October 15, 2002
AEP:NRC:2900-02
10 CFR 50.90

SUBJECT: Donald C. Cook Nuclear Plant Unit 1
Docket No. 50-315
Supplement to License Amendment Request for Appendix K
Measurement Uncertainty Recapture – Power Uprate Request
(TAC No. MB5498)

**DETAILED DESCRIPTION AND TECHNICAL EVALUATION
OF PROPOSED CHANGES**

FIGURE 3.4-2

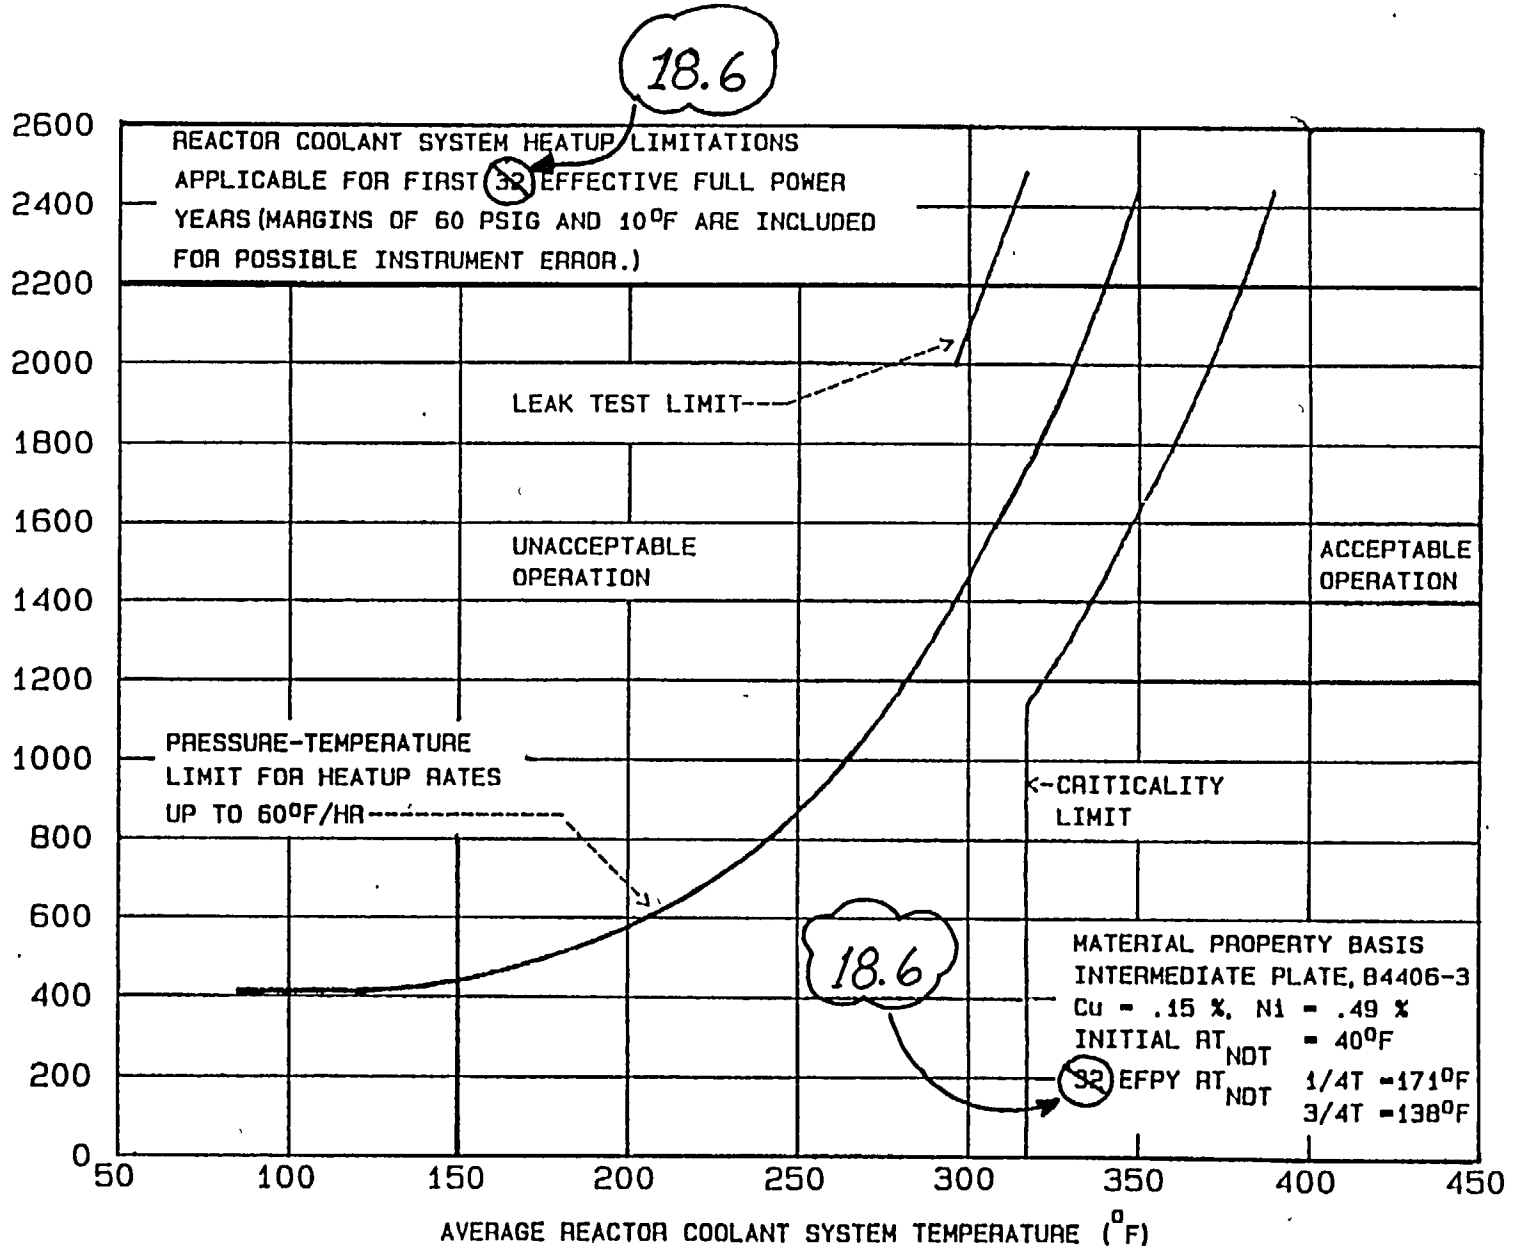
- I&M proposes to revise the two notes on TS Figure 3.4-2, "Reactor Coolant System Pressure-Temperature Limits Versus 60°F/hr Rate Criticality Limit and Hydrostatic Test Limit," and the two notes on TS Figure 3.4-3, "Reactor Coolant System Pressure-Temperature Limits Versus Cooldown Rates," such that the current limit of applicability, 32 effective full power years (EFPY), would be changed to 18.6 EFPY. This proposed applicability limit supercedes the limit of 28.4 EFPY that was proposed by Reference 1.

The technical basis for the new applicability limit of 18.6 EFPY in TS Figure 3.4-2 and TS Figure 3.4-3 is provided by the computation summarized in Attachment 3 to this letter. As stated in Attachment 3, the computation is based on the fluence resulting from the MUR uprate that was determined as described in Attachment 4. The technical basis for the proposed applicability limit provided in Attachment 3 takes into consideration questions posed by the NRC in Reference 7 on the changes I&M proposed in Reference 6 to the Unit 2 RCS pressure-temperature curves. The applicability of these questions to the Unit 1 pressure-temperature curve changes proposed in this letter is addressed in Attachment 5.

The existing reactor coolant system pressure-temperature curves in Unit 1 TS Figure 3.4-2 and TS Figure 3.4-3 are conservatively acceptable for 18.62 EFPY based on the uprated power level and considering the updated weld data adjusted for chemistry and temperature factors.
